**230385/F** Proposed renovation and adaptation of the existing Hereford Museum and Library to become a dedicated and enhanced facility for Herefordshire Museum Service and viable for the future. This would comprise a museum, education space, galleries, cafe, and staff facilities.

**230386/L** Proposed renovation and adaptation of the existing Hereford Museum and Library to become a dedicated and enhanced facility for Herefordshire Museum Service and viable for the future. This would comprise a museum, education space, galleries, cafe, and staff facilities.

### **Summary of comments**

Figure 1 and Figure 2 Heritage Plans Ground Floor Exhibition 2 XX-00-DR-A-16020 Rev P01

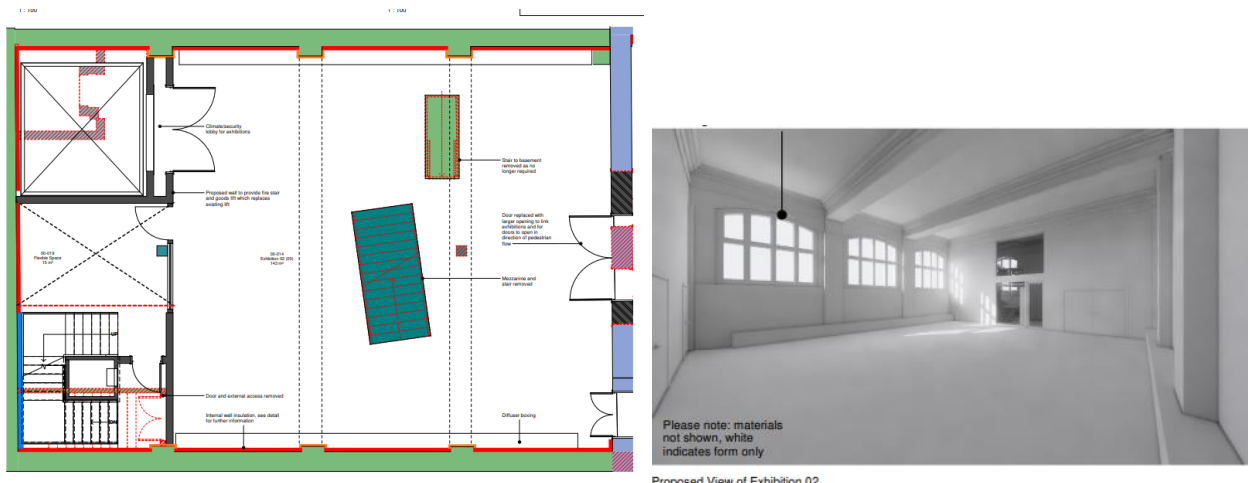
3.6.3 In addition clarification is sought as to the location of the new steel frame as referenced on page 7 of the Structural Report, which describes that “in order to accommodate the localized breaking out of existing floors at the rear of the building to accommodate the full height stairs and lift, a new steel frame has been introduced. This frame will provide both support for each floor level and trim the floor openings, but also provide necessary lateral stability to the existing gable masonry wall which will subsequently be unrestrained full height”. This steel frame is not readily apparent on the proposed floor plans or the Design and Access Statement, or Heritage Report for this floor. However the cross sections Section B-B-F XX-XX-DR-A-45505 Rev P01 has pale grey lines on the cross section, leading down below the basement with pile foundations, which appear to line up with the western pilaster. Full details of this steel work and its relationship with the pilasters is required. Figure 2 within the structural report suggests the proposed structural model, and seems to suggest extensive steelwork, that has not been included on the floor plans. Full details of the steel work proposed should have accompanied the listed building consent application as they are not included in the floor plans or exhibition view which suggests the retention of the pilasters, however figure 2 of the structural report suggest steelwork in front of the pilasters which is not indicated elsewhere in the application. Clarification in respect of the steelwork is required.

3.6.4 The proposed view on of exhibition 2 on Heritage Plans Ground Floor Exhibition 2 XX-00-DR-A-16020 Rev P01 indicates the pilasters on the northern elevation, however it is not considered that this degree of pilaster will be expressed by the use of 100 or 122.5mm. The Internal Wall Insulation is noted and not readily accepted in that the insulation would minimise the visual prominence of the pilasters which are a key feature in the design. It would be preferable for the IWI to not butt against the pilasters thereby retaining the original depth of the pilasters, and presenting “feature” insulation panel to display paintings and exhibits with the area between the pilasters and the pilasters themselves to have a slimmer form of insulation than the 60mm proposed such as aerogel or similar. No cross section of the insulation has been provided, which is specified as 100mm on the Heritage Plans Ground Floor Exhibition 2 XX-00-DR-A-16020 Rev P01, however other rooms have this figure but the sections show the insulation to be 122.5mm. Between the pilasters the insulation will visually reduce the depth of the pilasters, and precise details of how this is to be achieved is required. Further consideration in respect of the depth of insulation adjacent and on the pilasters is again requested in order that this element can be supported.

Figure 3 – reproduction of Figure 2 of the Structural report

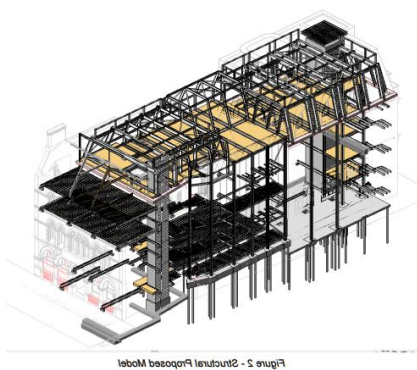
- a) Figure 2 within the Structural report indicates new beams/joists in this locality. These details should be clarified or provided before they can be considered.
- b) White window seals – exact type of seal and location to be agreed by condition
- c) Minor repairs to the balcony to be conditioned
- d) Details of the venting to be conditioned.

Photograph 11

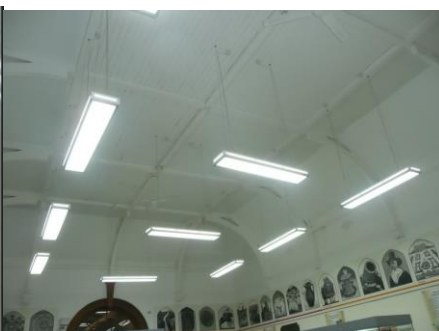
5.2.3 The Heritage Statement confirms that the insulation would stop below the existing corbels approximately at the height of the existing display panels. Whereas the Heritage Plans Third Floor Exhibition 3 XX-02-DR-A-16025 Rev P01 confirms that the lower external wall will be a total of 122.5mm thick, insulation and plaster however the upper wall would be insulated with a different material and should not exceed the depth of the architectural detailing. Clarification is sought in this regard as the three documents differ in the approach. Details of the upper wall insulation is required, in addition to why the historic plaster needs to be removed.

Figure 4 plate 7 from Visual Impact Assessment

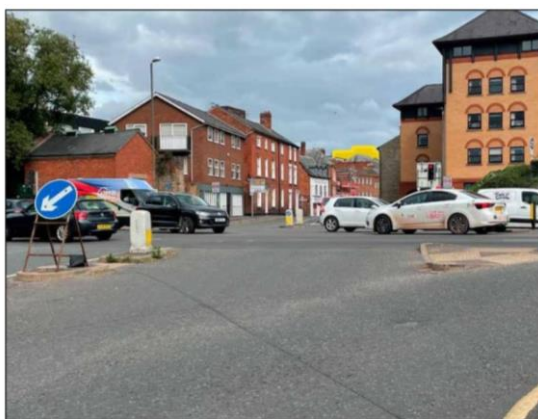
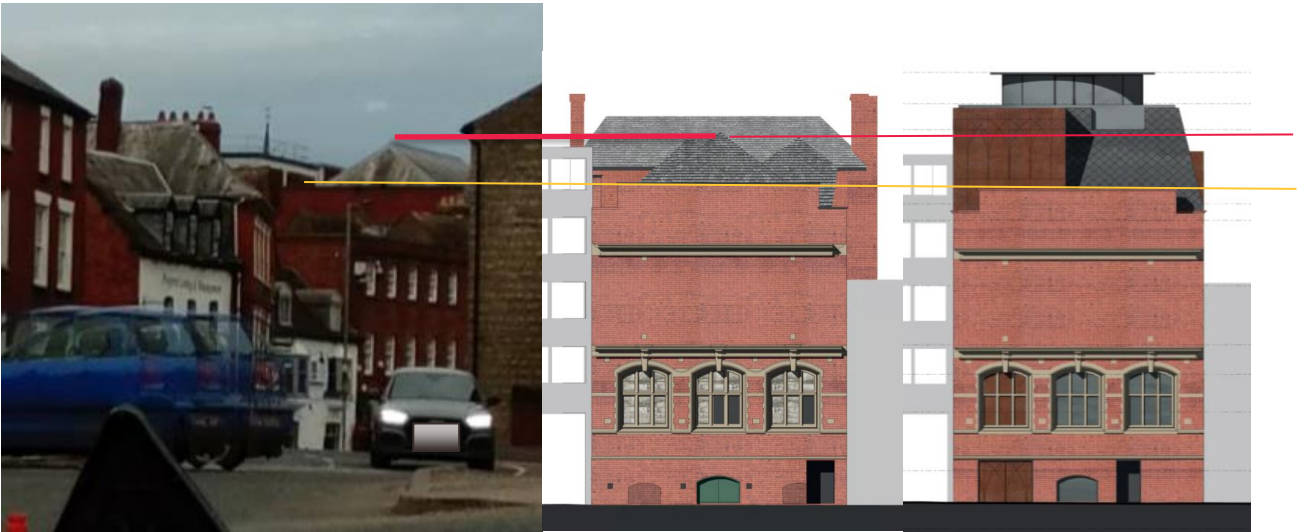
7.4.3 In terms of the Aubrey Street frontage, this elevation has changed from pre-application discussions by the provision of the lift to the fifth floor. This has resulted in an uncomfortable square box projecting in the north west corner of the building, which is accentuated by a change in material, and is visible on both the west and south elevation, and as such will be readily visible on the approach along Barton Street and King Street. I note that the view from Barton Street has not been included in the Visual Impact Assessment, although was identified as a key view during pre-application discussions. Nonetheless it is considered in plate 7 of the Archaeology and Heritage Based Assessment. However, it is not clear if the representation on plate 7 is entirely accurate as the new roof appears to be sited behind the existing roof which is to be removed. As such it is not considered that the impact will be not as depicted in plate 7.

7.4.4 However the roof will be more visible than indicated sited immediately behind the brick parapet, as a comparison with a photograph taken from the traffic lights at Barton Road, compared with the existing elevations and the proposed elevations indicate. The red line indicates the height of the existing ridge of the 1912 section of the building and the red line the existing parapet. All Saints Church spire grade II\* is visible on the left hand side of the photograph and Berrington House grade II\* in the left foreground

Photograph 15 and 16 Aubrey Street elevation of museum viewed from King Street

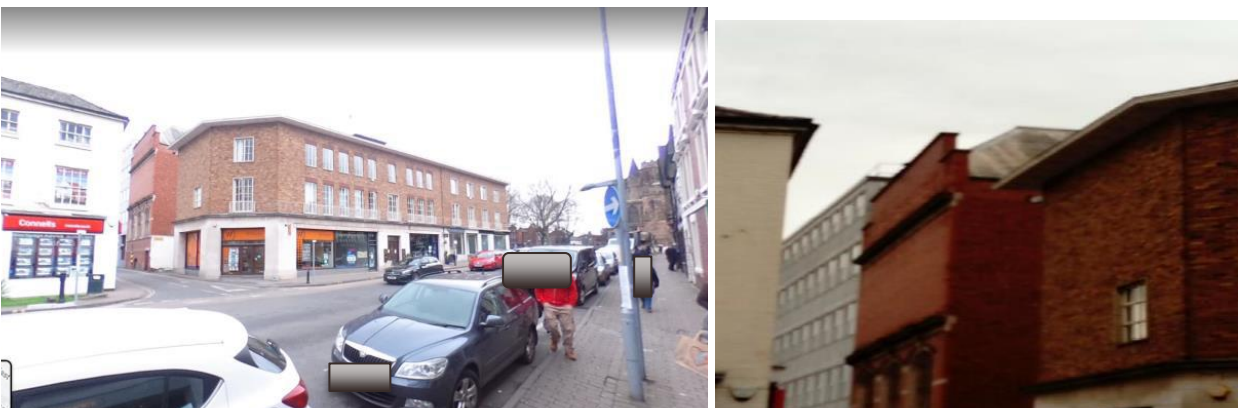
7. 4.5 At this key gateway into the city that affords a view of the rear of the museum, this elevation has to be carefully considered. Whilst the elevational drawings of the existing roof may be accurate, they are by their nature 2 dimensional, and the height and impact of the existing 1912 roof, is not always adequately represented in a 2D drawing, as the 1912 roof stands more prominent than the other pitched roofs to the rear of the museum, which is difficult to illustrate 2 dimensionally. However photographs or viewing from King Street and the corner of Bridge Street illustrate the existing roof scape. Being in 2D the drawings suggest that the main roof of the museum is the dominant roof when considering the rear elevation, however this is not the case due to the complex change in levels and the size of the roof. In some locations the main museum roof is not visible such as the photographs and plate 3 of the Archaeology and Heritage Based Assessment.
